Amex Knitting & Dyeing Industries Ltd. (Unit 2)

Sufia Plaza, 327/3/B-C, South Jattrabari, Dhaka-1204, Bangladesh
(23.708897, 90.437078)
12th June, 2014

Observations

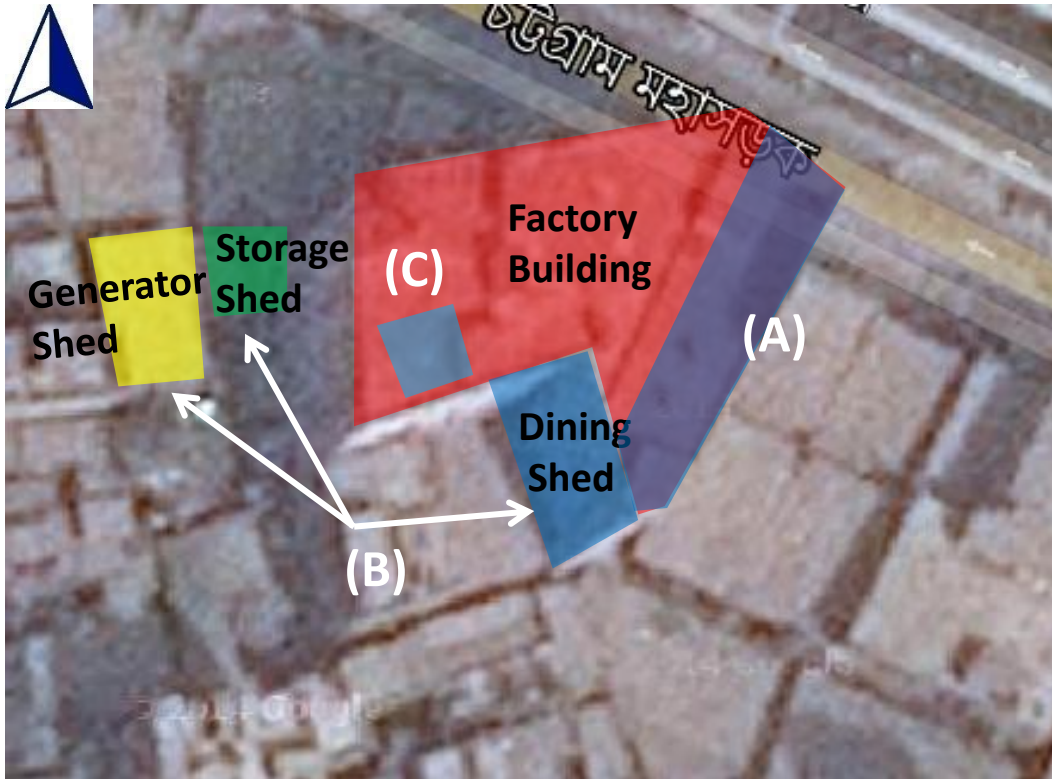
Additional Roof structures observed

RC Tank over South side of Roof

Cursory calculations indicate that weight of roof-top concrete tank and its contents contribute significantly to the potential overloading of supporting columns, assuming typical concrete strength

Communication Tower over South side of Roof

Additional weight and wind loads from roof-top communication tower are supported by roof structure

Billboards on N East and N West sides of Roof

Additional weight and wind loads from Billboards are supported by roof structure

7	High stresses in columns	Continue to implement load plan	6-months
8	Additional Roof structures observed	As part of the Detail Engineering Assessment (DEA) check columns, slabs and beams supporting the Water Tank and other roof structures.	6-weeks
9	Additional Roof structures observed	Building Engineer to review as-built structure and if required, prescribe relevant structural improvements to ensure these meets BNBC requirements as part of the DEA (refer to Item 1 above).	6-weeks
10	Additional Roof structures observed	Carry out any structural alterations directed by the engineer.	6-months

Indicative Building Plan

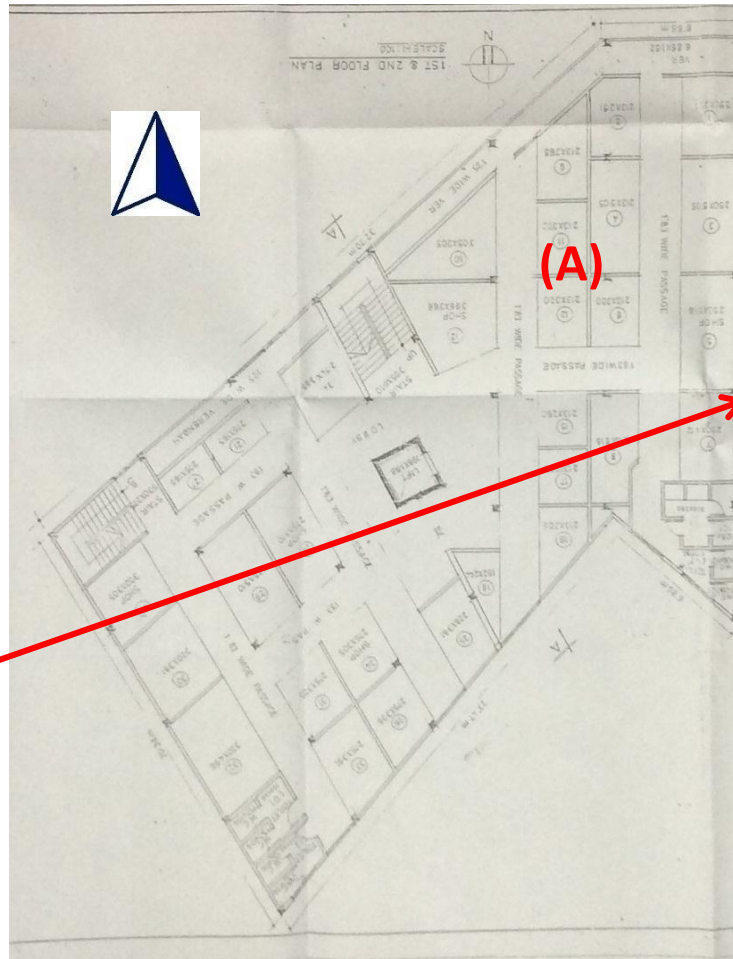
Building appears to be made from separate structures.

East part (A) of building and West part (B) appear to be separate structural systems but appear to be connected along the interface line.

Two sets of offset columns observed along the interface.

East part of building appears to have internal columns made from two halves, with a gap in between.

Cracking was observed in beams and columns along the interface line.
